South Texas Project Electric Generating Station P.O. Box 289 Wadsworth, Texas 77483

South Texas Project
Units 1 and 2
Docket Nos. STN 50-498, STN 50-499
Response to Requests for Additional Information for the
Review of the South Texas Project, Units 1 and 2,
License Renewal Application – Set 26 (TAC Nos. ME4936 and ME4937)

STP Response to Requests for Additional Information

The staff has completed its evaluation of the response to request for additional information (RAI) B2.1.37-4 related to the Selective Leaching of Aluminum Bronze plant-specific aging management program (AMP). As a result of this review, there are several open questions.

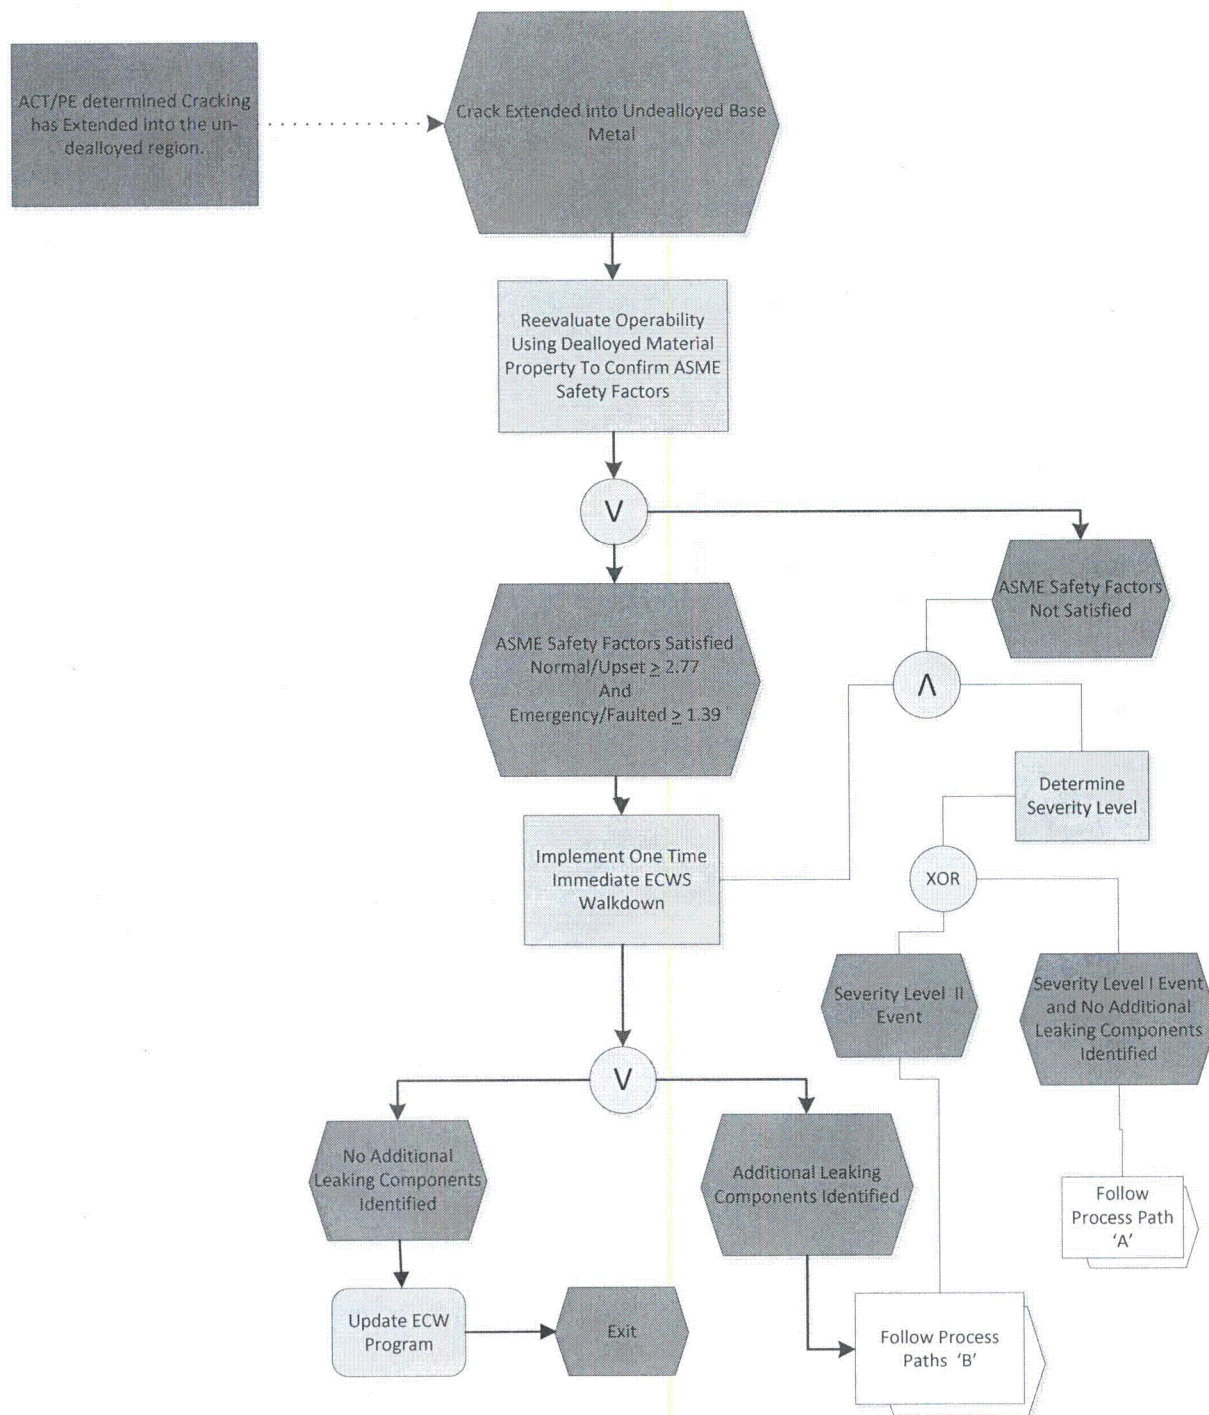
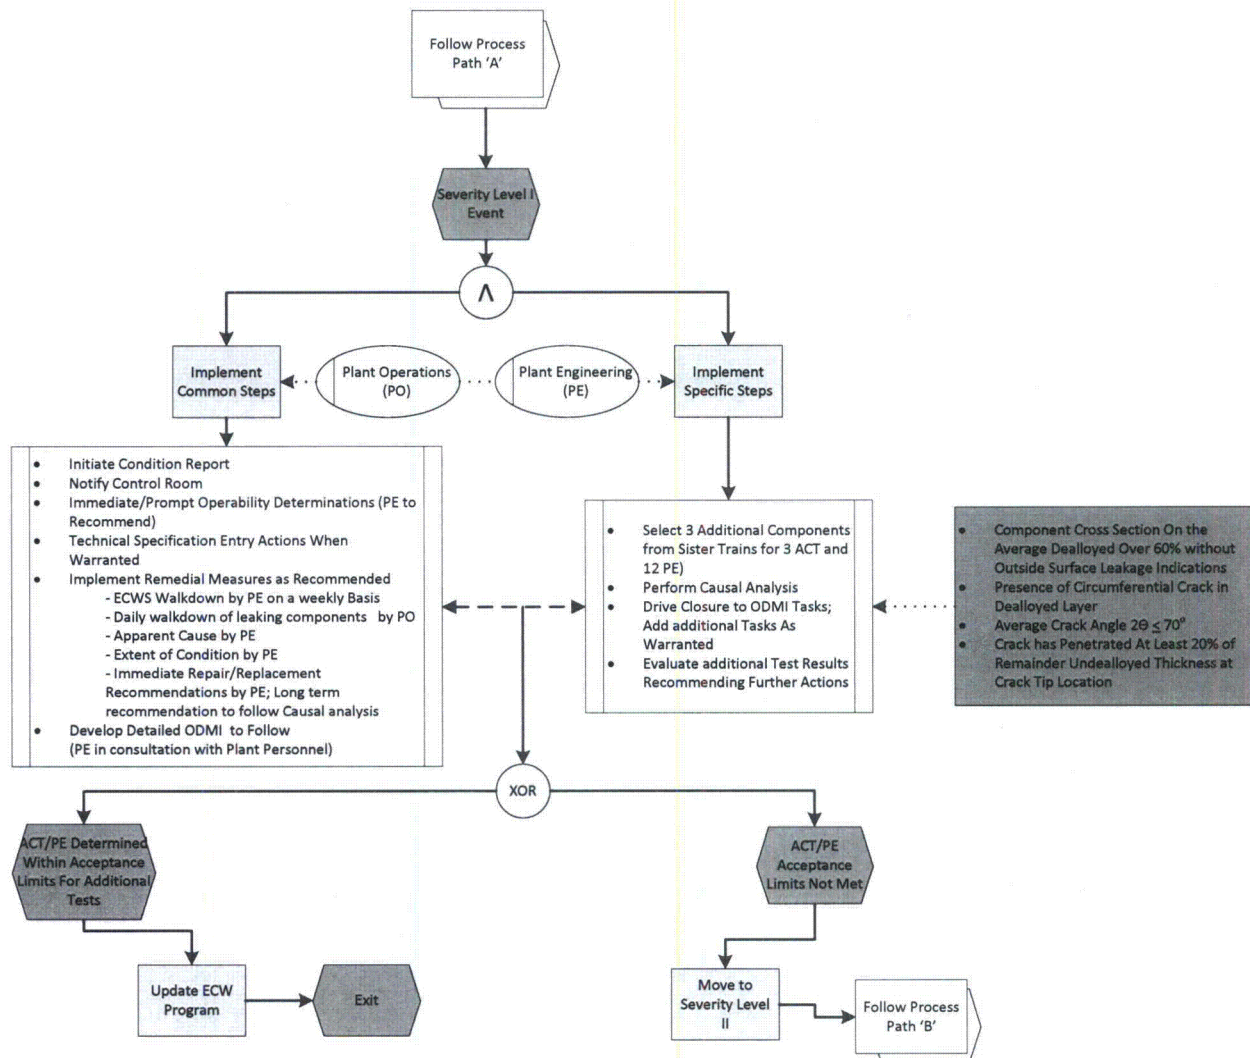
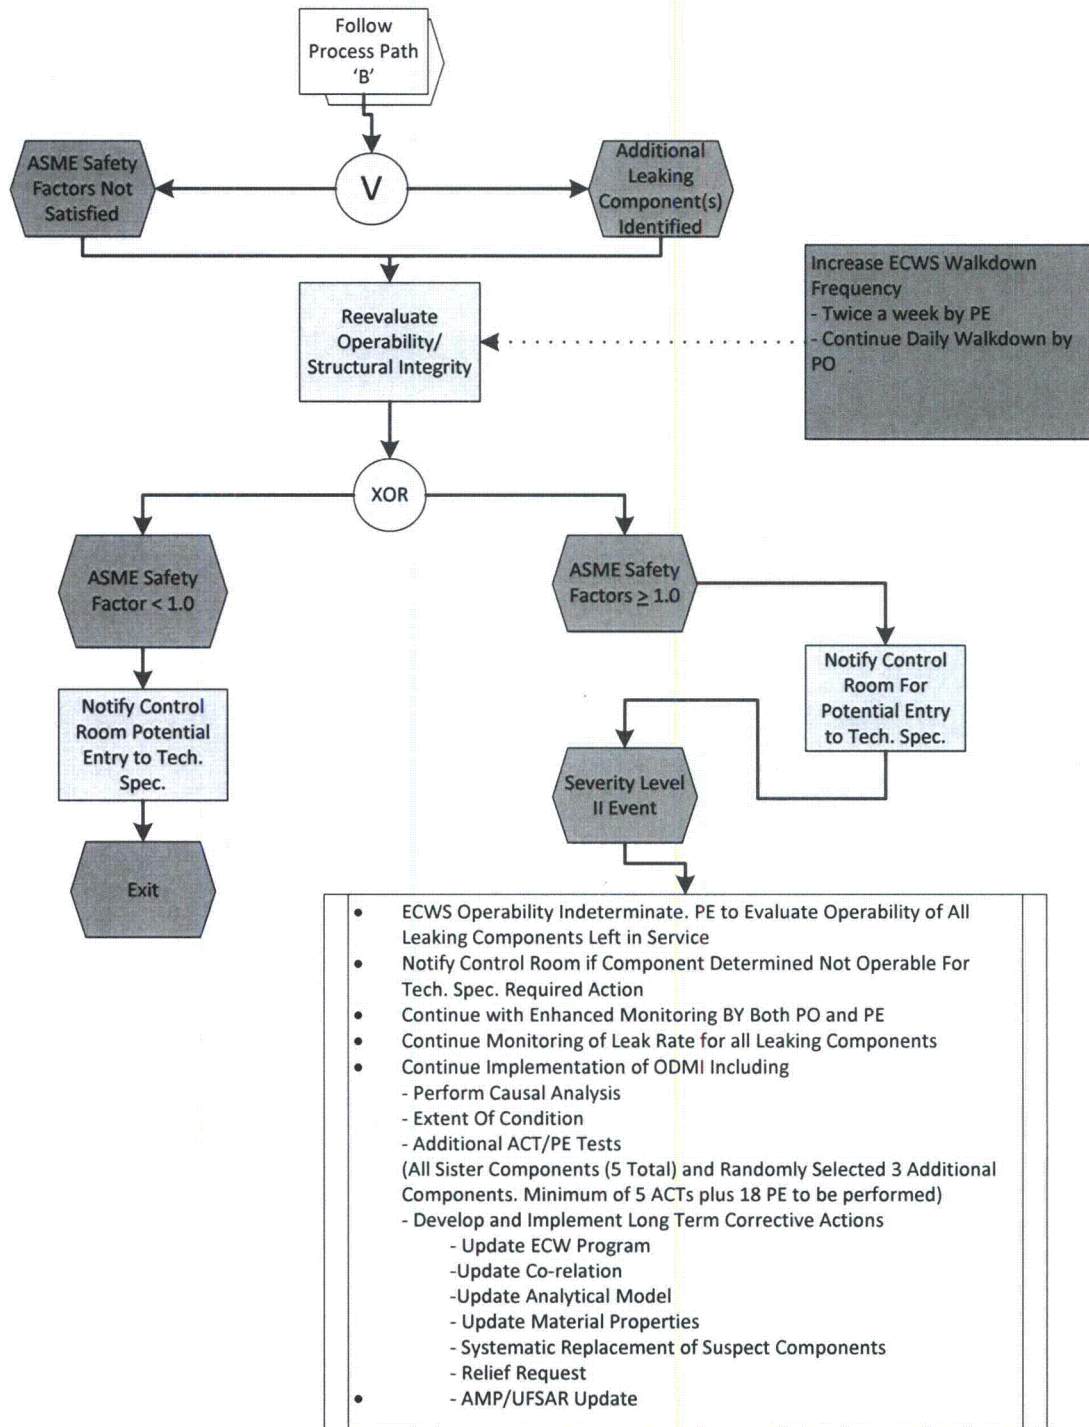
- In the correlation in AES-C-1964-5, the observed OD crack angle is used to derive an average through-wall dealloying angle. However, the critical bending stress curves in AES-C-1964-1 use a crack angle, not an average through-wall dealloying angle. The staff lacks sufficient information to be able to understand the link between the correlation and its use in the critical bending stress curves. Note that the response to RAI B2.1.37-4, Enclosure 1, page 3 of 9, incorrectly characterizes the correlation, "[t]he examination results were used to establish a correlation between length of a flaw on the outer diameter and the size of any internal crack and the extent of the dealloyed region of the component."

Crack penetration length will determine severity levels.

Severity Level	Acceptance Criteria	Number of Components to be Tested	Probable Action
II	Length of ID crack exceeds 70 degrees (2θ) and has penetrated at least 20% of base material	5 ACTs and 18 PEs randomly selected component from affected train	<ul style="list-style-type: none"> - Enter Technical Specification - STP may seek temporary relief from the NRC for continued operation until root cause can be determined
I	Length of ID crack is NOT exceeding 70 degrees (2θ) and penetration in base material is less than 20% of base material	3 ACTs 12 PEs	<ul style="list-style-type: none"> - Enter Technical Specification - Notify Control Room - Seek temporary relief from the NRC for continued operation until root cause can be determined - Additionally tests are required to confirm potential entry to Severity Level II

Specific remedial measures are based on severity as recommended by the following Decision Flowcharts.
